## ON-SITE SEWAGE DISPOSAL SYSTEM HOWARD COUNTY HEALTH DEPARTMENT BUREAU OF ENVIRONMENTAL HEALTH

ADDRESS: 18222 Flower Hill Way, #132 PHONE NUMBER: 301-351-8746  
Gaithersburg, MD 20879

ADDRESS: 3601 Willow Birch Dr PROPERTY OWNER: \_\_\_\_\_

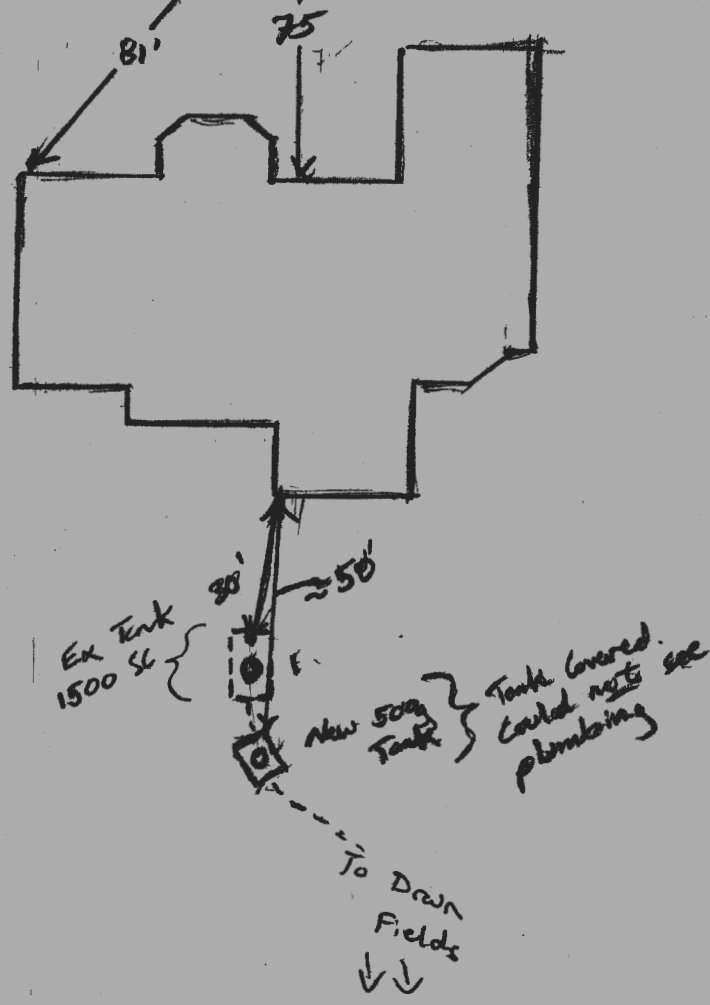
TRENCHES:	Trench to be feet wide. Inlet feet below original grade. Bottom maximum depth feet below original grade. Effective area begins at feet below original grade. feet of stone below distribution pipe.
LOCATION:	
NOTES:	Need to add a 500 gallon piggy back tank to an existing 1500 gallon tank. Layout inspection required prior to installation.

PRE-CONSTRUCTION 5/21/07 O.K. to install 500 gallon tank downhill of existing tank. Tank cannot be deeper than 3'. (KB)

INSTALLATION 5/23/07 Tanks installed and covered before I arrived. Contractor took pics of installation. Used vertical pipe extending down off of baffle tee's, roughly 12"-16" on inlet and outlet of new 500g S.T. Told contractor pictures showing complete of this is acceptable. (KW) 5/24/07 Pics of baffles w/ vertical pipe refitted. Sys. complete. (KW)
